Tillbridge Solar Project
EN010142

Volume 6
Environmental Statement Addendum
Document Reference: EN010142/APP/6.6

September 2024
Revision Number: 00

FIGURE NUMBER
Figure 7

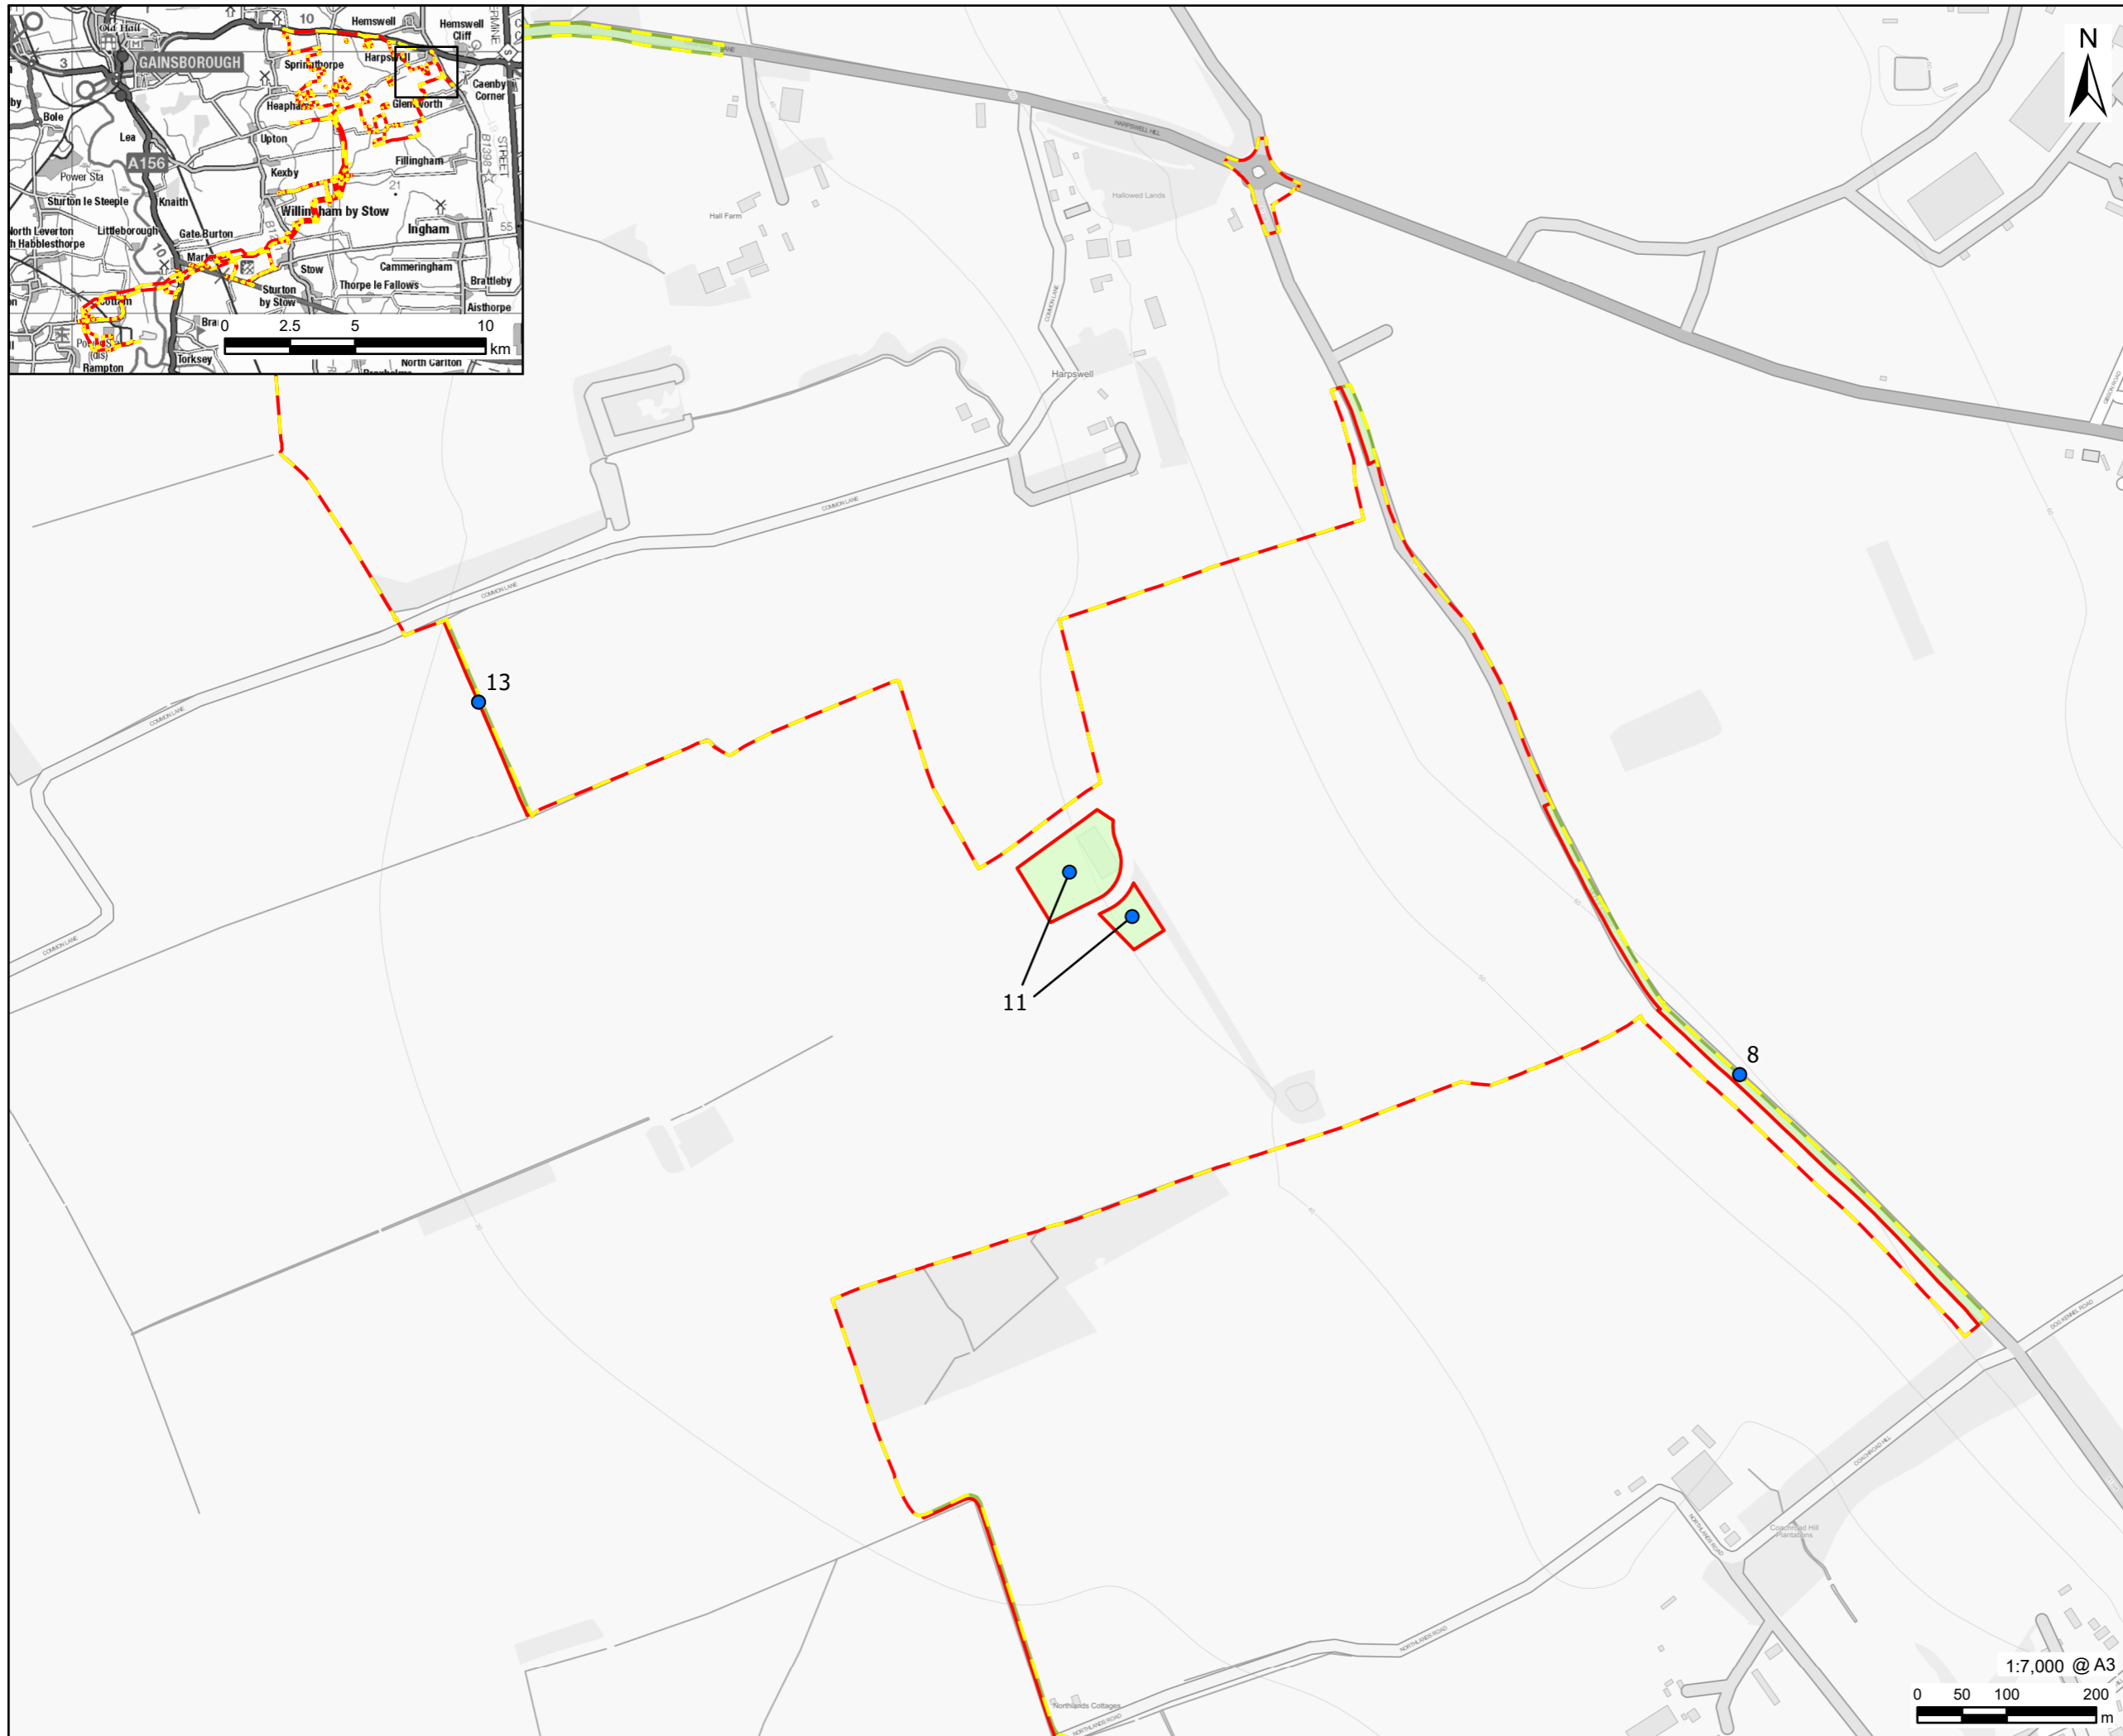
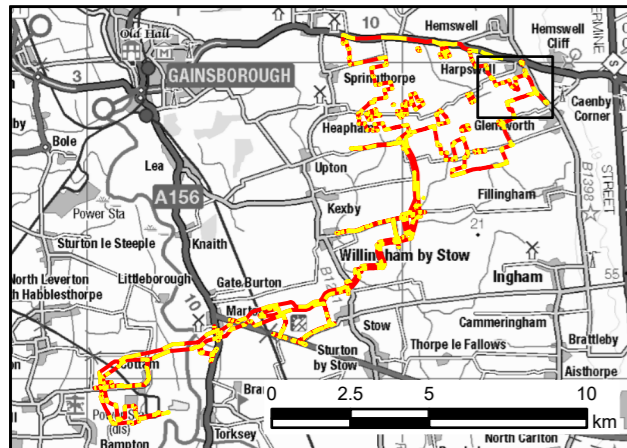
- 2.1.16 This change (see **Figure 7: Change 7**) will result in the removal of highway extents along the A631 Harpswell Lane to the east of Principal Site Access 3 (the access leading to Pickering & Sons Farm). Upon further review, this land is not required to facilitate alterations to the layout of existing streets or to allow traffic management measures to be put in place.
- 2.1.17 This change will not result in a change to the Scheme layout or engage any new land interests given that it is a reduction in Order limits.

FIGURE NUMBER
Figure 8

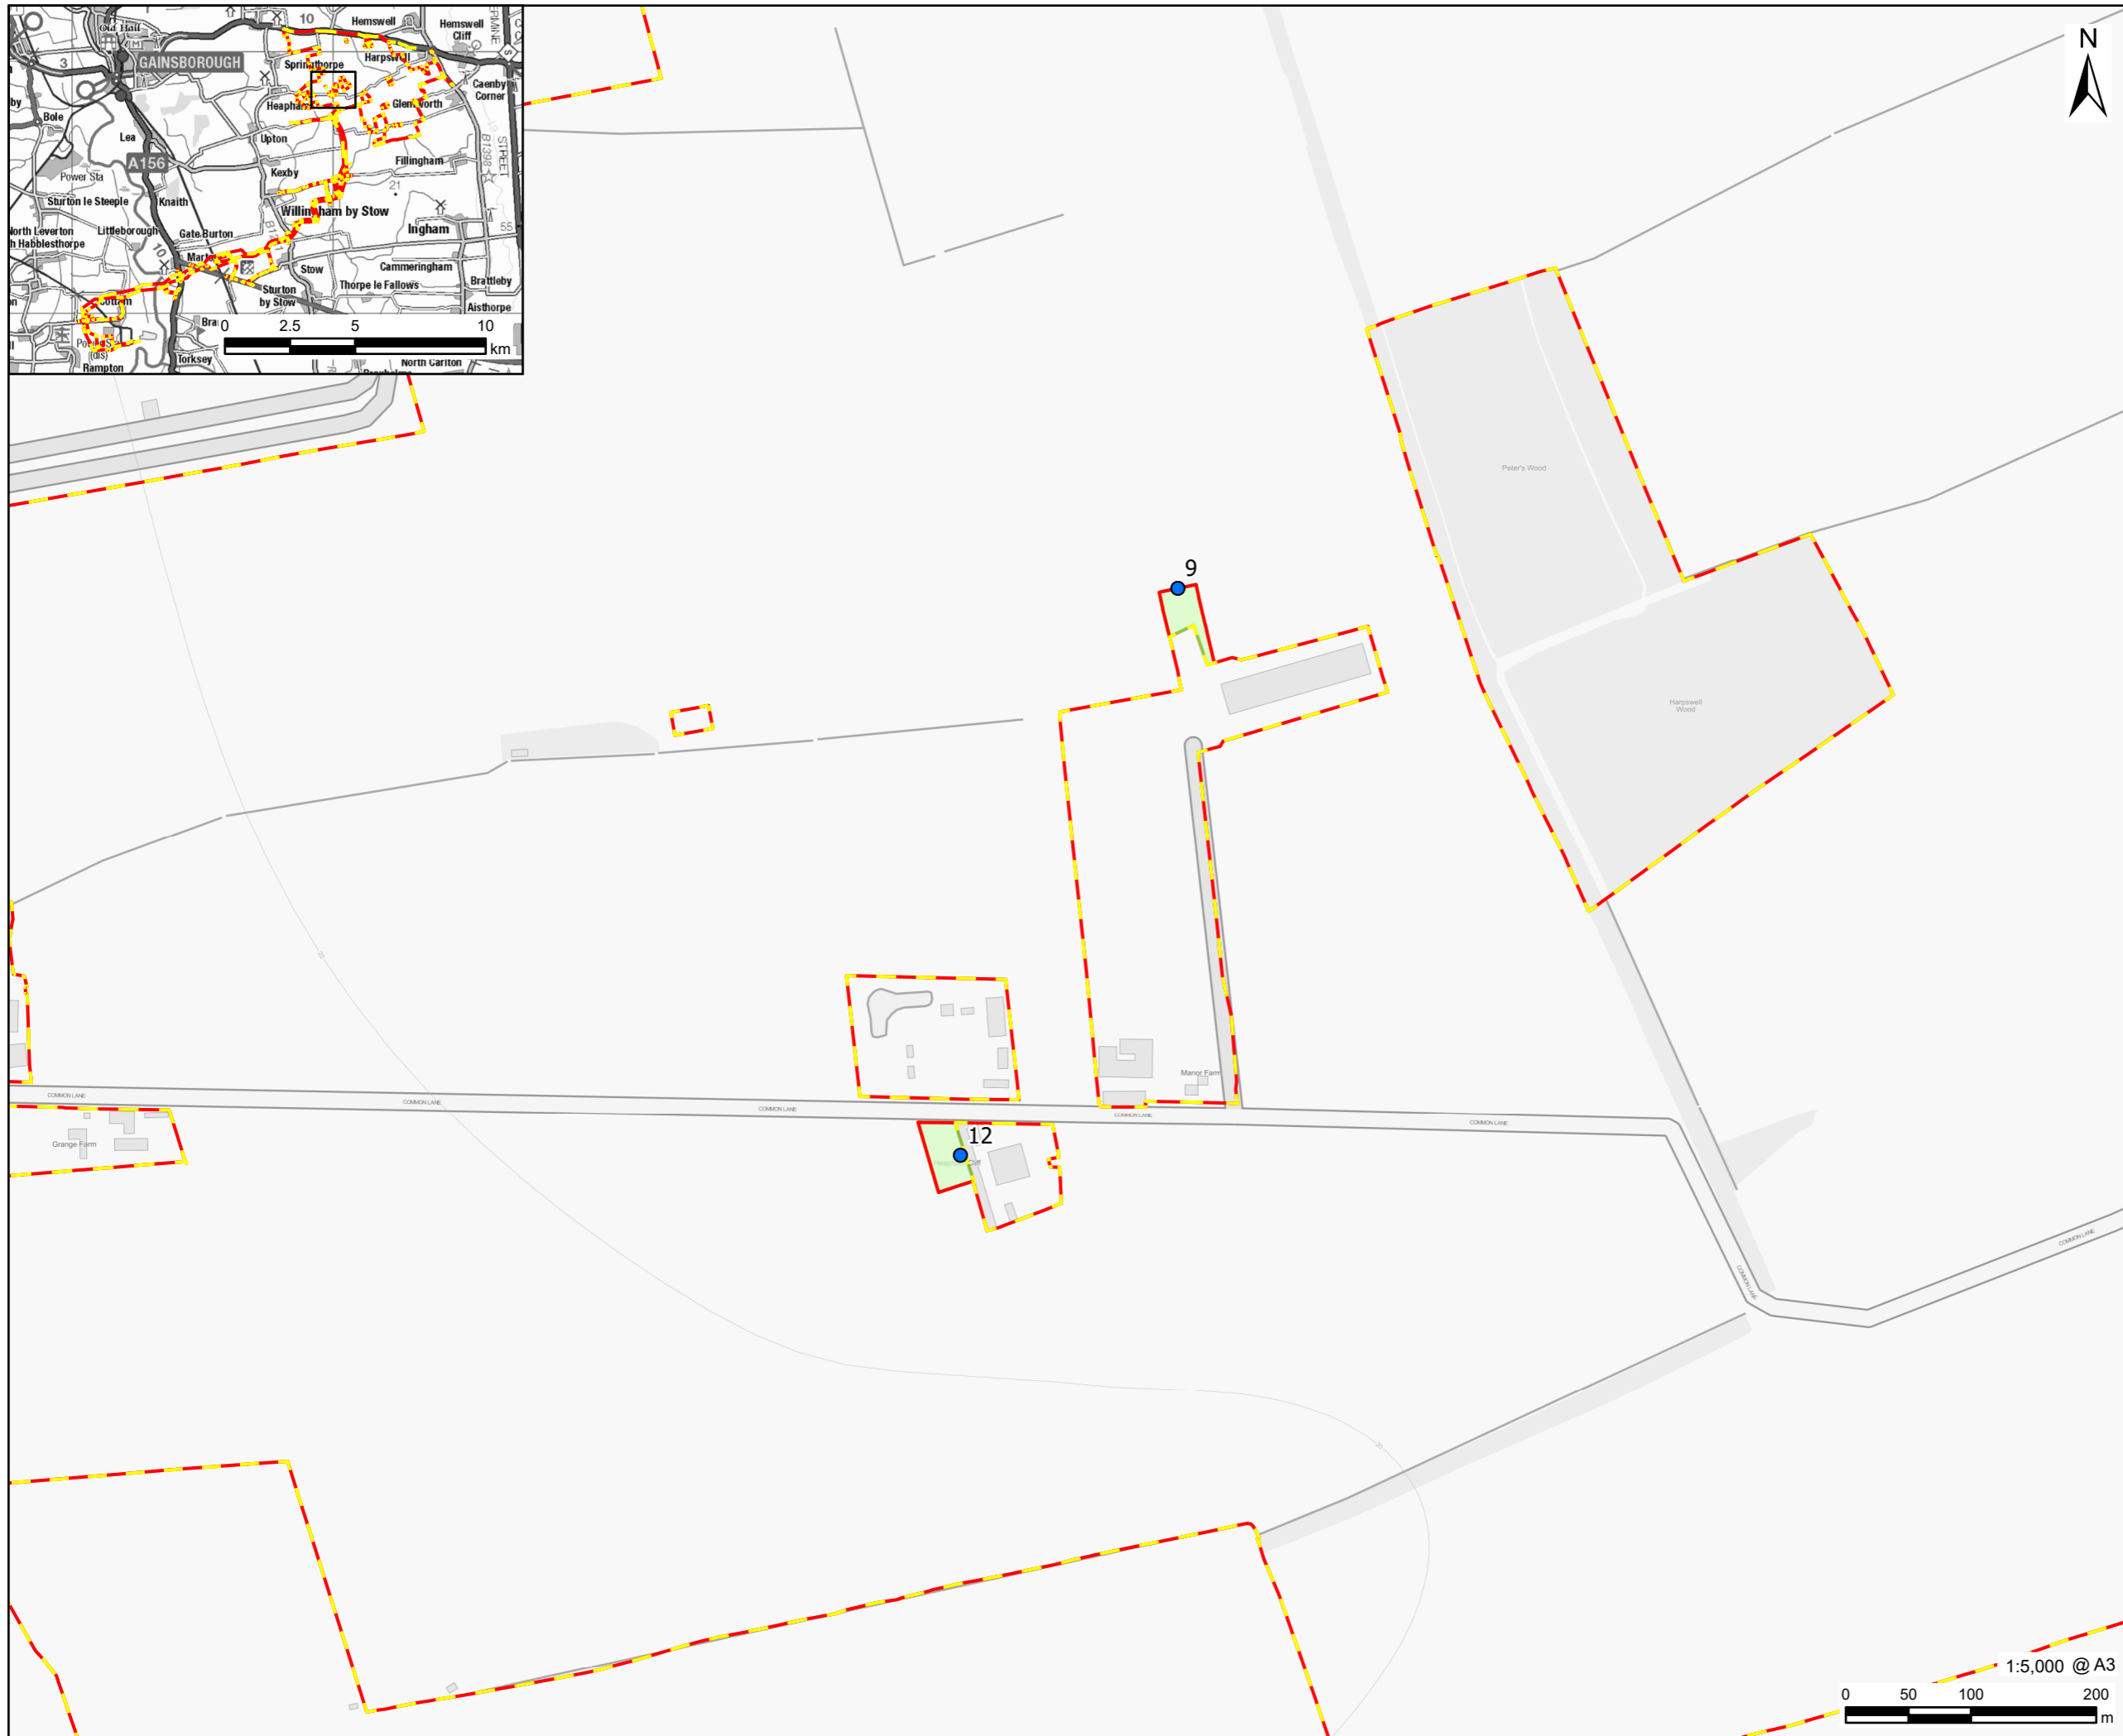
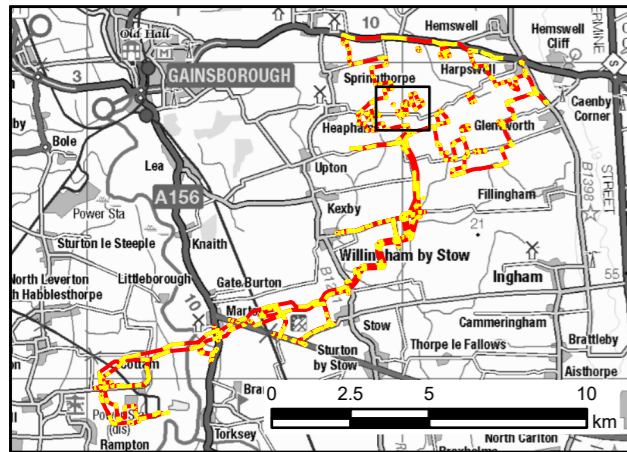
- 2.1.18 This change (see **Figure 8: Change 8, 11 & 13**) will result in the removal of highway extents along B1398 Middle Street, where no works are proposed. Upon further review, this land is not required to facilitate alterations to the layout of existing streets or to allow traffic management measures.
- 2.1.19 This change would not result in a change to the Scheme layout.

- 2.1.24 This change (see **Figure 8: Change 8, 11 & 13**) proposes a reduction to the Order limits following ongoing discussions and engagement with Affected Parties. The change involves the removal of land from the Order limits that the Affected Party would like to retain for their own use. Land from Plots 4-07 and 4-08 as shown on the **Land and Crown Land Plans [EN010142/APP/2.2(Rov01)]** has been reduced and modified as a result of the proposed change.
- 2.1.25 The change would remove an area of land from the Sensitive Archaeological Site (SAS) 23 and SAS 24 and require a proposed hedgerow to be

- 2.1.29 It is proposed that a track adjoining the eastern boundary of the Principal Site is removed from the Order limits following ongoing engagement and discussions with Affected Parties. Land from Plots 3-22 and 7-07 as shown on the **Land and Crown Land Plans [APP-006]** has been removed as a result of the change (see **Figure 8: Change 8, 11 & 13**).
- 2.1.30 This change will not result in a change to the layout of the Scheme. No new land interests would be engaged through this change. No additional land outside the current Order limits is required.

FIGURE NUMBER
Figure 9

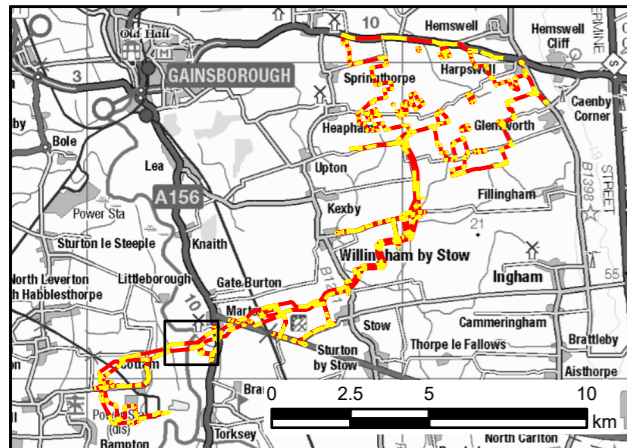
- 2.1.20 This change (see **Figure 9: Change 9 & 12**) proposes a reduction to the Order limits at Work No. 1, 2, 6 and 9 as shown on the **Works Plans [EN010142/APP/2.3(Rov01)]** following ongoing discussions and engagement with affected landowners (hereafter referred to as 'Affected Parties'). Plot 5-07 as shown on the **Land and Crown Land Plans [EN010142/APP/2.2(Rov01)]** has been reduced and modified as a result of the change.
- 2.1.21 This change will not result in a change to the Scheme layout and no new land interests would be engaged through this change. No additional land outside the current Order limits is required.

- 2.1.27 This change (see **Figure 9: Change 9 & 12**) proposes a reduction to the Order limits following ongoing discussions and engagement with Affected Parties. The change involves the removal of an area of private garden from the Order limits that the relevant Affected Party would like to retain in its existing use. Land associated with Plot 5-18 as shown on the **Land and Crown Land Plans [EN010142/APP/2.2(Rev01)]** has been modified and reduced in size as a result of this change.

FIGURE NUMBER
Figure 10

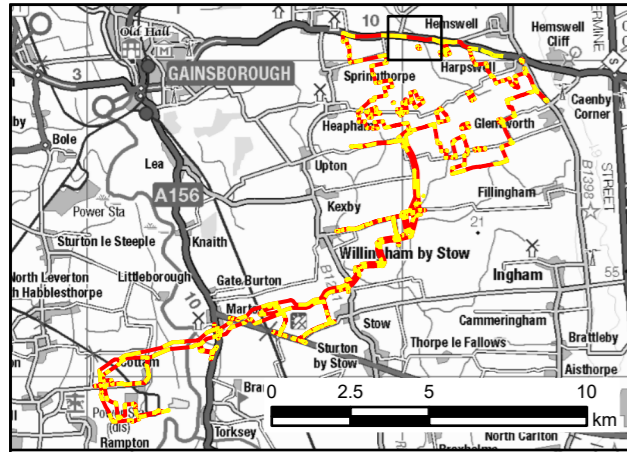
- 2.1.31 This change (see **Figure 10: Change 14**) relates to a reduction in Order limits following ongoing engagement and discussions with the Canal and River Trust who have requested that Plots 20-07 and 20-12 as shown on the **Land and Crown Land Plans [APP-006]** are removed from the Scheme as this relates to their operational land, which they require to retain in existing use.
- 2.1.32 This change will not result in a change to the layout of the Scheme. No new land interests would be engaged through this change. No additional land outside the current Order limits is required.
- 2.1.33 Canal and River Trust have also requested that **Chapter 3: Scheme Description** of the ES and the **Outline Design Principles Statement** clarify

that the minimum 5 m Horizontal Directional Drill (HDD) depth under the River Trent is measured from 'the lowest surveyed point of the River Trent riverbed'. This change has been incorporated into the updated **Chapter 3: Scheme Description** of the ES [EN010142/APP/6.1(Rev01)] and the **Outline Design Principles Statement** [EN010142/APP/7.4(Rev01)].
